Addendum #1 to Final Environmental Impact Report for the
Glen Mor 2 Student Apartments Project
(SCH# 2010081020)

Project Title: Glen Mor 2 Student Apartments
Project Number: 956334
Project Location: The project is located on the University of California, Riverside (UCR) campus, generally northwest of Big Springs Road and Valencia Hill Drive. The site is south of the existing Glen Mor 1 and Pentland Hills residential complexes and east of Lothian residence hall.
City: Riverside
County: Riverside

Addendum #1 for Glen Mor 2 Student Apartments
Modified Arroyo Improvements
September 25, 2012

Figure 3.3-5
Arroyo and Jurisdictional Water Impacts
Glen Mor 2 Student Apartments
Revised September 2012 for Arroyo Improvements Addendum

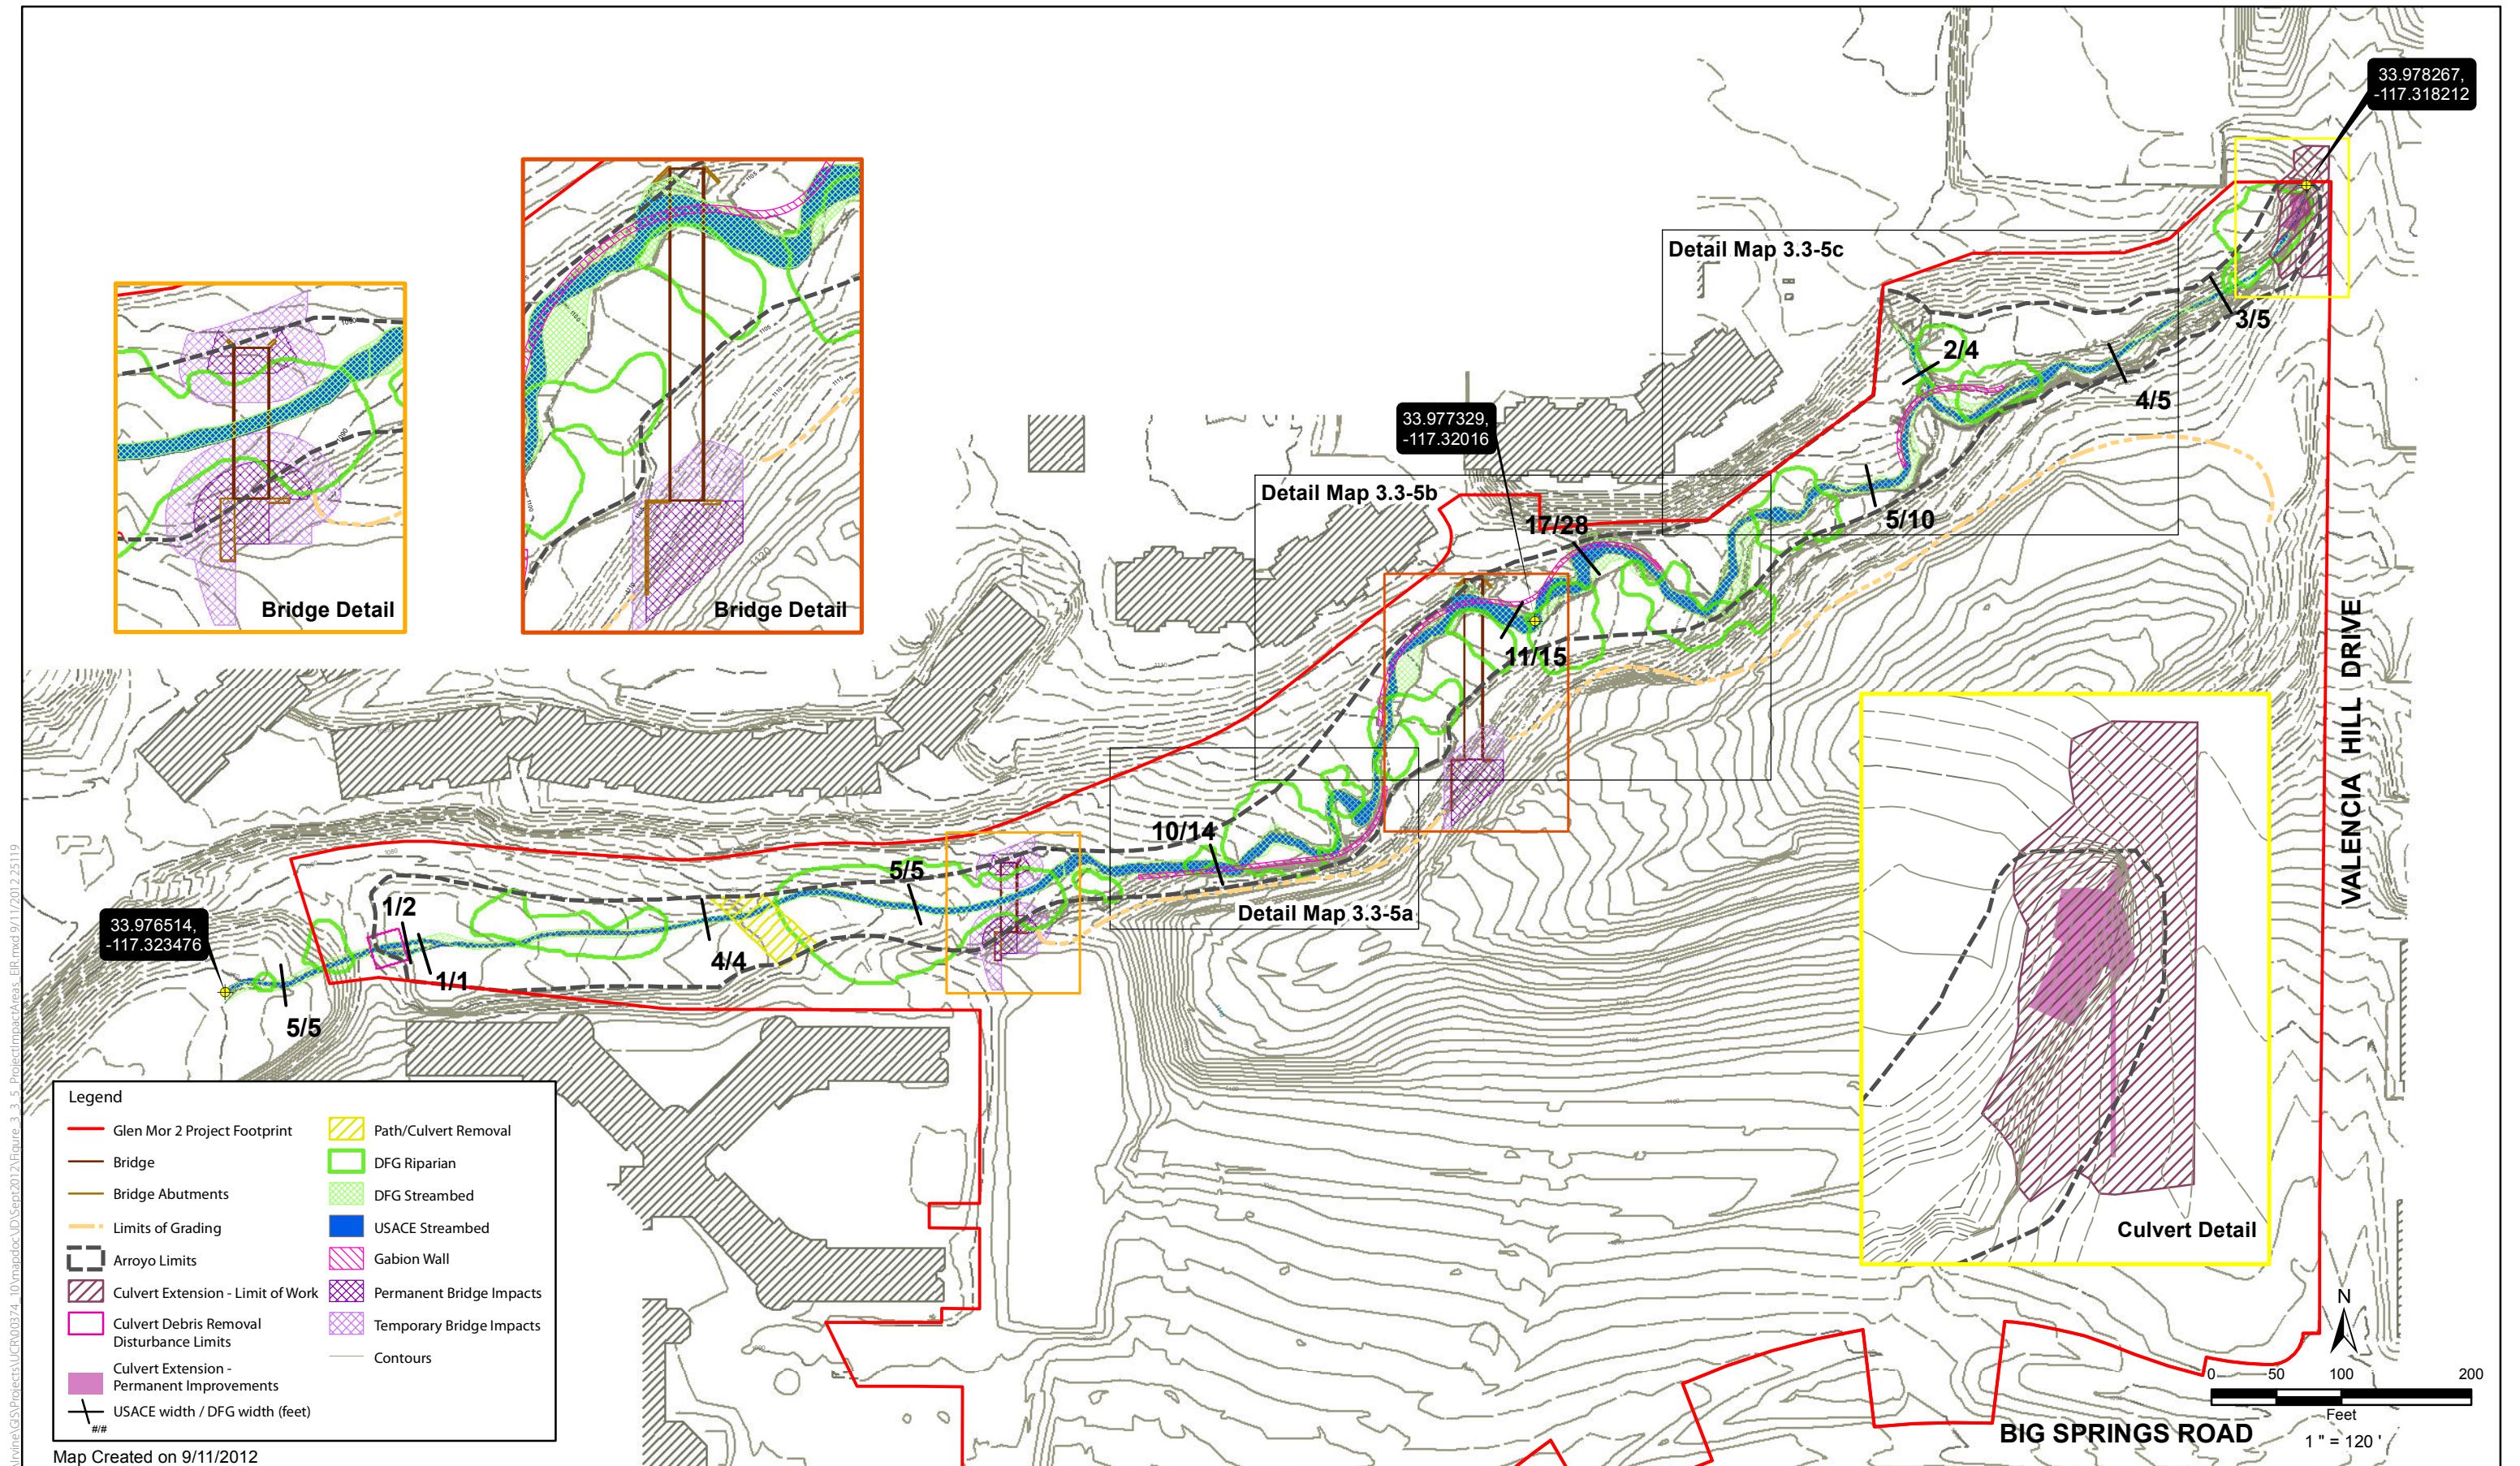
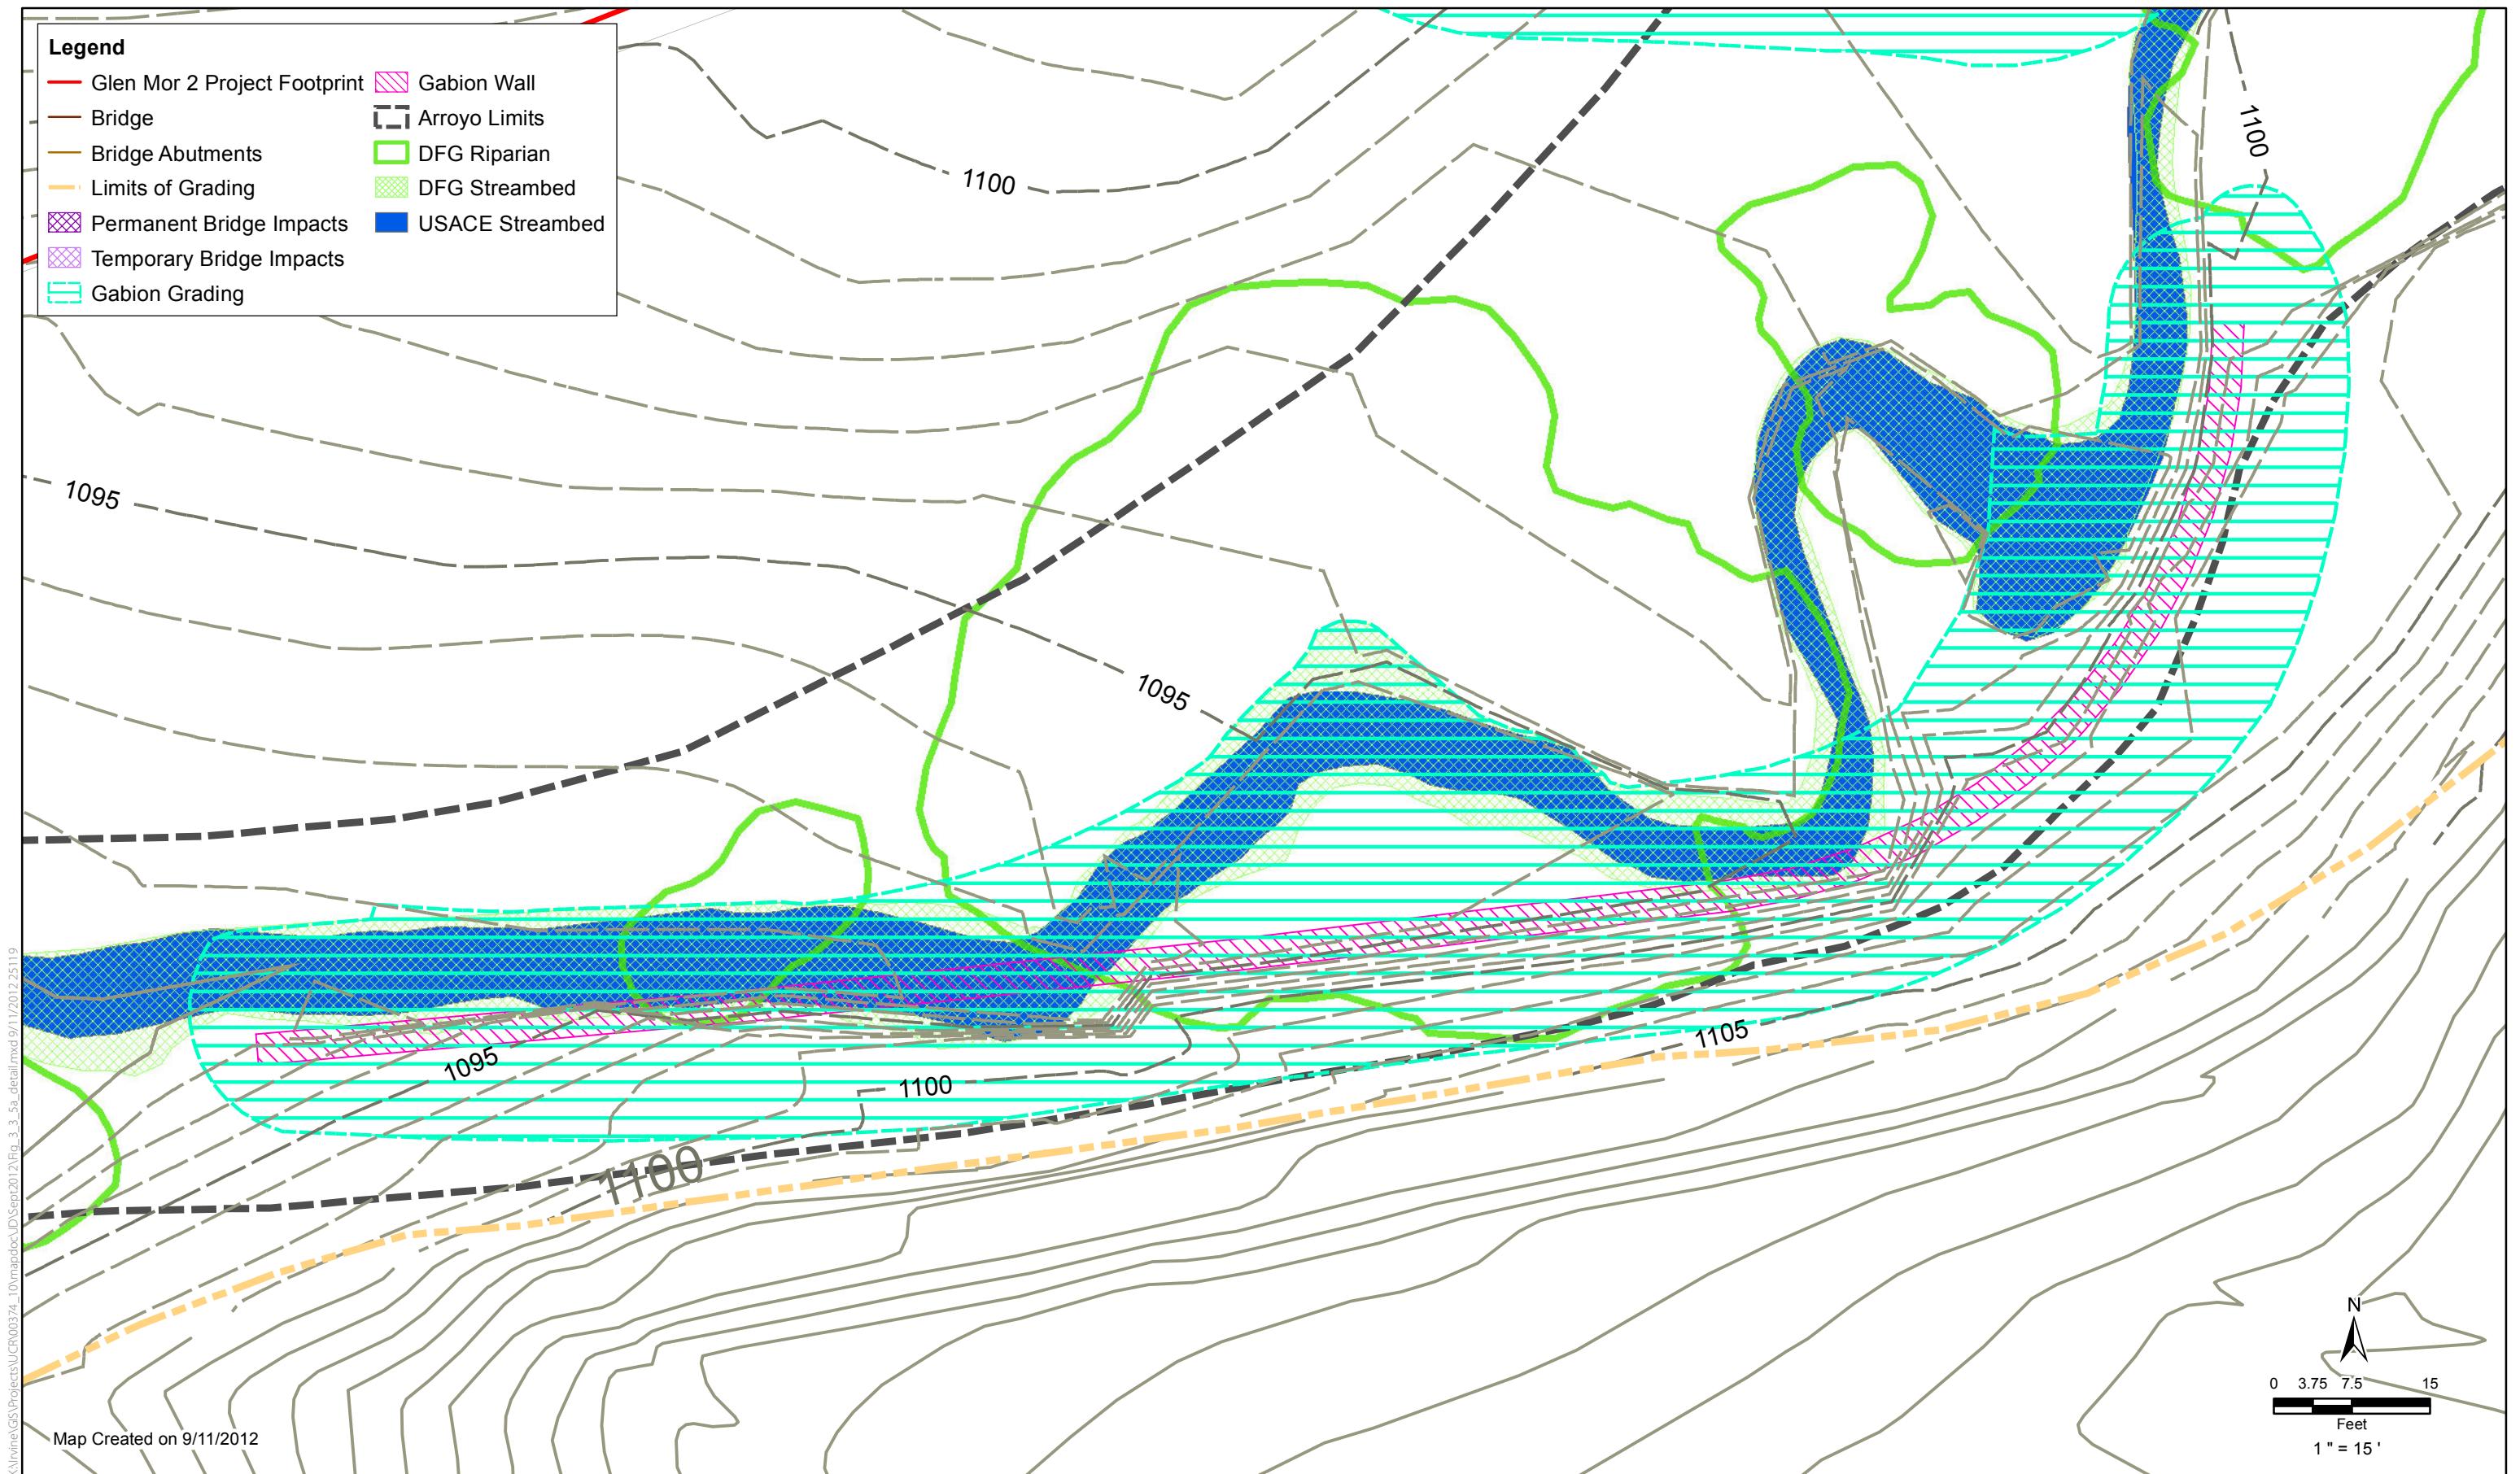
The modified arroyo improvements make several changes in the nature and extent of impacts upon jurisdictional stream resources habitat. An updated evaluation of impacts upon jurisdictional resources, was conducted for the modified improvements. The results are summarized in the attached updated Table 8 (replaces Tables 8 on page 5-17 of Appendix I in Volume 3 of the certified EIR). The relationship of proposed improvements to mapped jurisdictional resources is illustrated in the attached updated Figure

3.3-5, including new detail figures 3.3-5a, 3.3-5b, and 3.3-3c (replaces Figure 3.3-5 following page 3.3-8 of the Draft EIR Volume). Impacts are increased, typically by factors of two to three times for all components, except impacts to DFG riparian. Despite the magnitude of the increases, the overall magnitude of impacts remains limited, with total temporary impacts to approximately 0.12 acre of waters of the United States (844 feet of streambed) and 0.45 acre of DFG jurisdiction (825 feet of streambed), and permanent impacts to approximately 0.03 acre of waters of the United States (373 feet of streambed) and 0.05 acre of DFG jurisdiction (467 feet of streambed). The increased impacts primarily arise from the added gabion wall components and the associated temporary excavation limits. The requirements under Mitigation Measures BIO 3 through 7 ensure that impacts are minimized and that finished conditions include replacement plantings of similar type and acreage. The proposed modifications to Mitigation Measures BIO 3 and BIO 4 merely elaborate on aspects related to a specific tree and do not alter the conclusion as to significance of impacts after mitigation. Considering the limited magnitude of impacts, together with the minimization and compensation measures provided for in the adopted mitigation monitoring and reporting program, the modified arroyo improvements do not present the potential for new significant impacts or a substantial increase in the severity of previously identified impacts to jurisdictional water resources. LRDPEIR PP 4.4-2(a), LRDPEIR mitigation measure 4.4-3(a), and project-level mitigation measures BIO 3 through BIO 7, will continue to apply, in accordance with the adopted Mitigation Monitoring and Reporting Programs for both the LRDPEIR and the Glen Mor 2 project (as amended by this Addendum).
